Final Status of SG EV

Report on topics discussed in SG EV in the context of the GTR#15 Amendment#6

IWG WLTP web-audio meeting, June 4th, 2020

Submitted by SG EV leading team:

Overview family concept for OVC-HEV

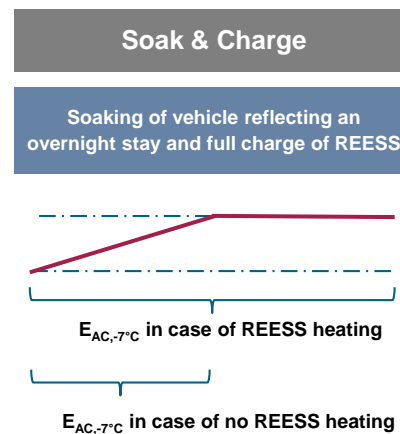
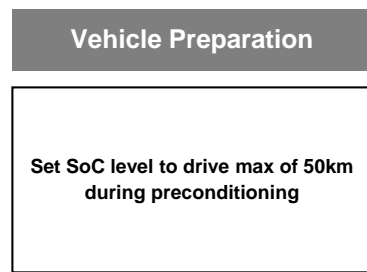
In the case of a Type 6 family consisting of OVC-HEVs, the manufacturer shall specify

- at least one vehicle configuration representative for either PMR_H or PMR_L , whichever is expected to be the worst-case for criteria emissions
- measurement for criteria emissions
-
- the vehicle configuration with the highest combined energy consumption, i.e. the highest combined cycle energy demand and energy consumption for heating. The selection shall be made in agreement between the manufacturer and the approval authority
- measurement for worst case range and electric energy consumption

Agreed Low Temp Test Procedure for PEV

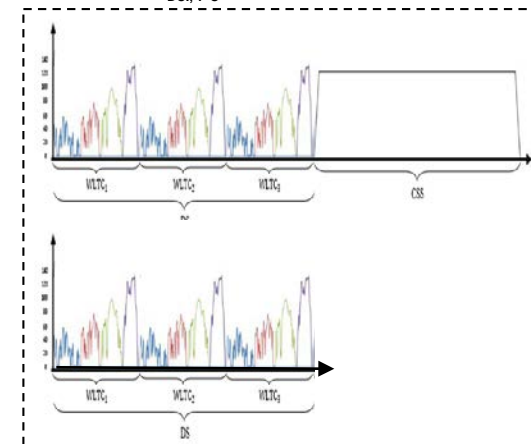
If no REESS heating, stop E_{AC} measurement and disconnect from grid; at the option of the manufacturer: E_{AC} measurement can continue and vehicle can remain connected to the grid
